TPB Ref.: A/YL-TT/781

Proposed Temporary Warehouse & Open Storage (Excluding Dangerous Goods) with Ancillary Facilities & Associated Filling of Land for a Period of 3 Years at Lots 1299, 1305 S.A (Part), 1305 S.B RP (Part), 1306 S.A, 1306 S.B (Part), 1307, 1308, 1309 RP, 1310, 1317 RP, 1318, 1360 (Part), 1392 (Part), 1393 (Part), 1394, 1395, 1396, 1397, 1398 S.A & B, 1399 (Part), 1402 (Part), 1403 (Part), 1407, 1408, 1409, 1410, 1411, 1412, 1413, 1414, 1415, 1416, 1417, 1418, 1419, 1421, 1422, 1423, 1424, 1425, 1426, 1427, 1428 (Part), 1429, 1430, 1431, 1433, 1434 (Part), 1435 (Part), 1538 (Part), 1539 (Part) and 1540 in D.D.118 and Adjoining Government Land, Tai Shu Ha Road West, Tai Tong, Yuen Long, N.T.

In response to the further comments of CE/MN, DSD, we are glad to submit the response to comments and the duly signed Drainage Impact Assessment in the attachment.

Comments		Responses
Comments from Drainage Services Department received 30 Sep 2026 via email [Contact person: Mr. LOU Tai-yeong, Tel: 3965 8929]		
General

Drawing No :	Revision :
FIGURE 2.2a	0
Scale : AS SHOWN	Date : JUN 2026

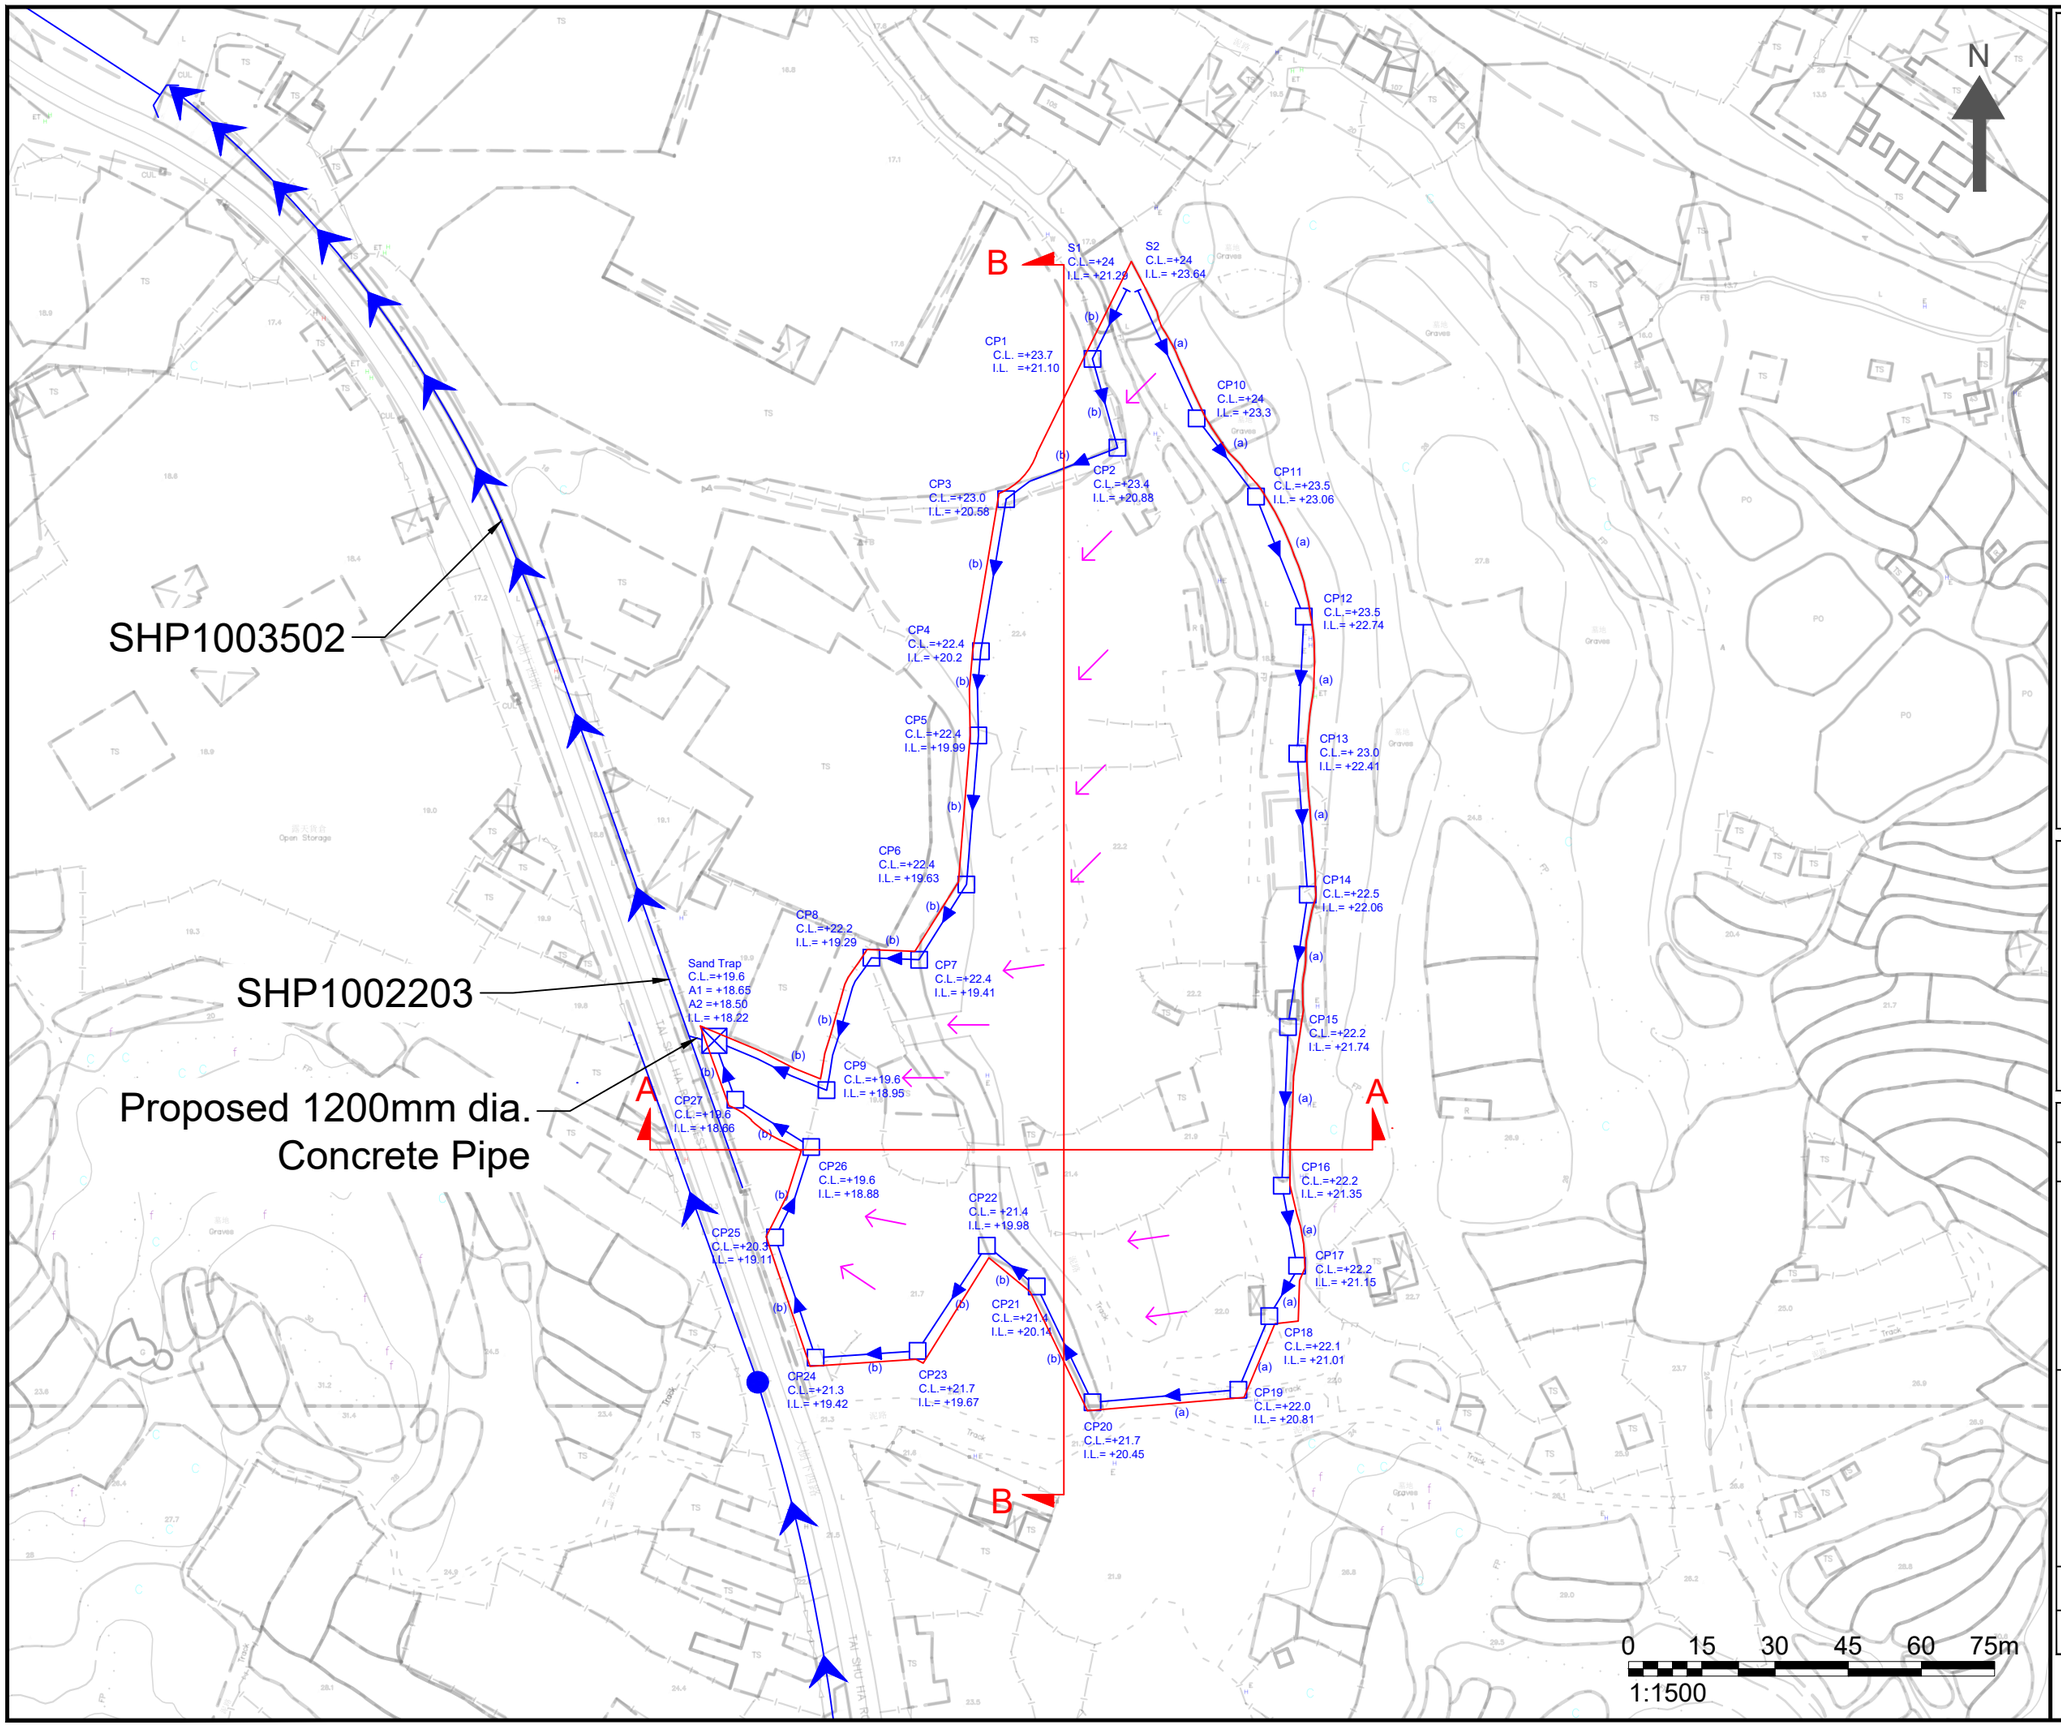
2.	Figure 2.2a – Please state the gradient of the proposed u-channels (i.e. 1:100 in Appendix C) for clarity. It seems that the gradient of the proposed 375mm u-channel from CP17 to CP20 is not consistent with the design 1:100 in Appendix C, please review the invert levels.	The invert levels are revised accordingly.

3.	Figure 2.2a – The invert level at the sand trap (A2 = +18.95) should not be higher than the invert level at its upstream catchpit CP27 (+18.68), please review.	A1 and A2 of sand trap is revised to +18.65 mPD and 18.50 mPD respectively.

Drawing No : FIGURE 2.4a	Revision : 0
Scale : AS SHOWN	Date : JUL 2026

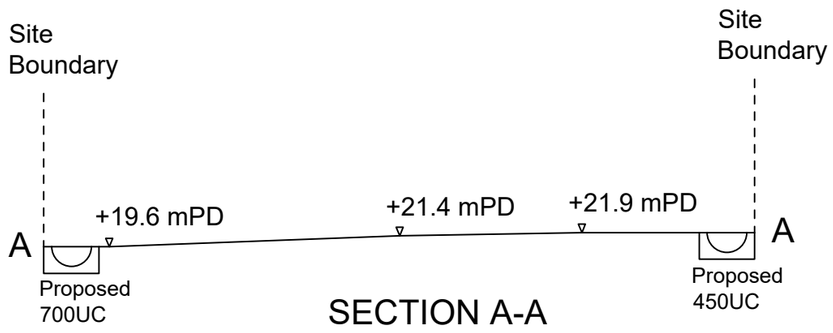
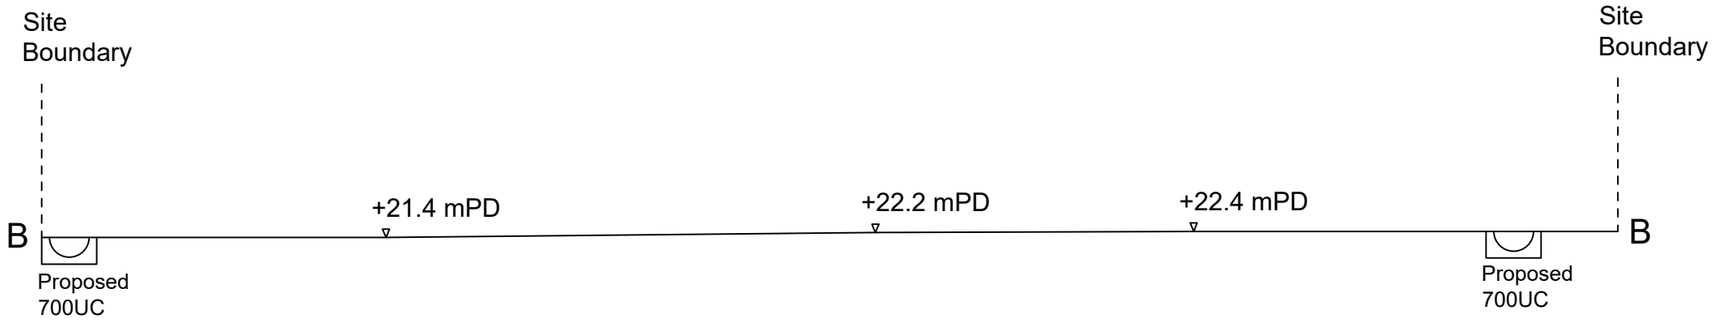
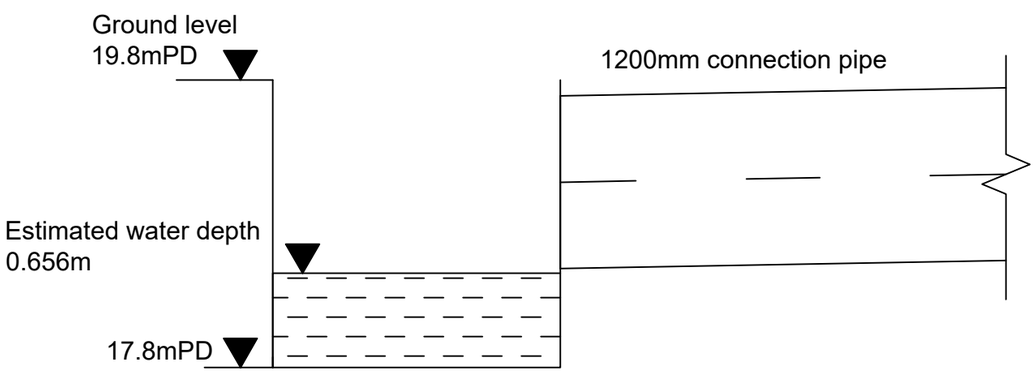
4.	Figure 2.4a – The proposed 700mm UC at the right hand side is not consistent with the proposed 375mm UC in Figure 2.2a, please review.	Figure 2.4a is revised accordingly, the cross section of site is reviewed.

Figure 7.1 Chart for the Rapid Design of U-shaped and Half-round Channels up to 600 mm

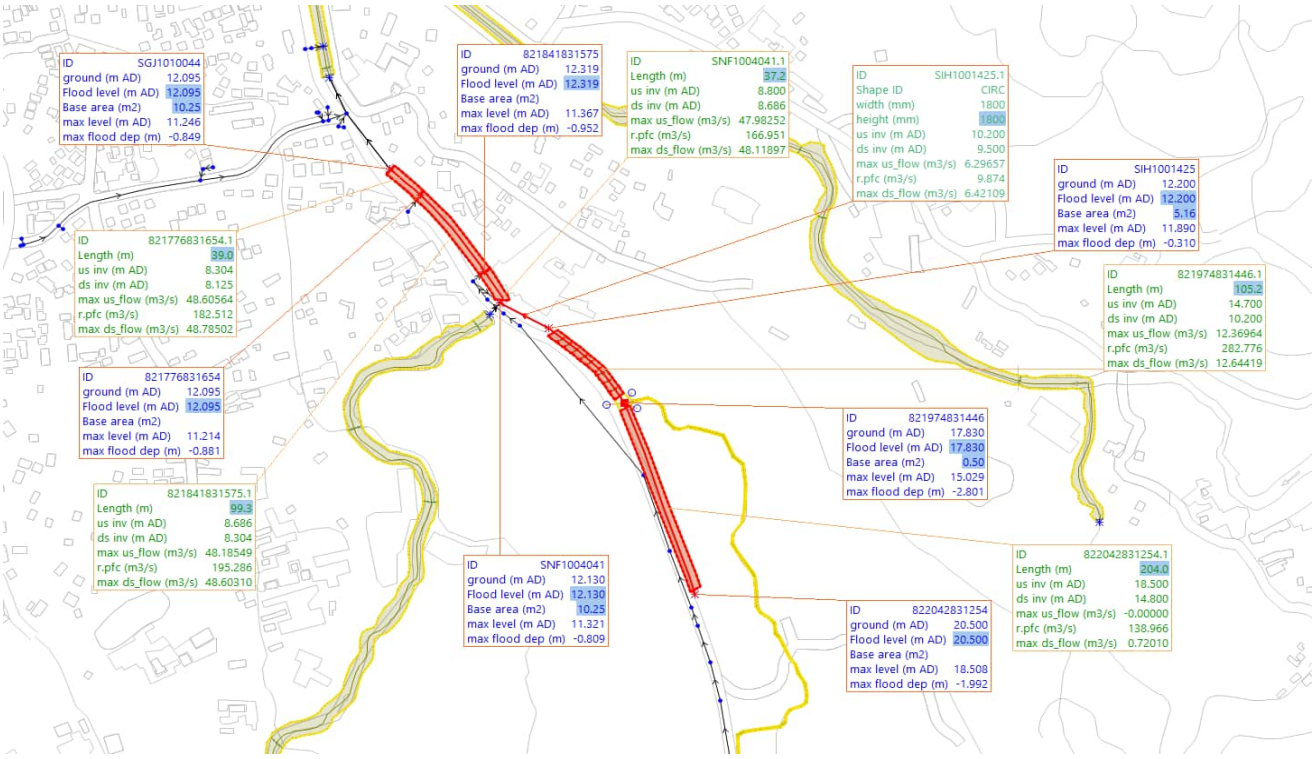
5.	Appendix C – It appears that the capacity of the proposed 375mm UC is less than $0.252m^3/s$, please check against GEO Technical Guidance Note No. 43.	Revised to 450mm UC in accordance to Figure 1 - Chart for the rapid design of U-shaped and half-round channels up to 600 mm in GEO Technical Guidance Note No. 43 (TGN 43).
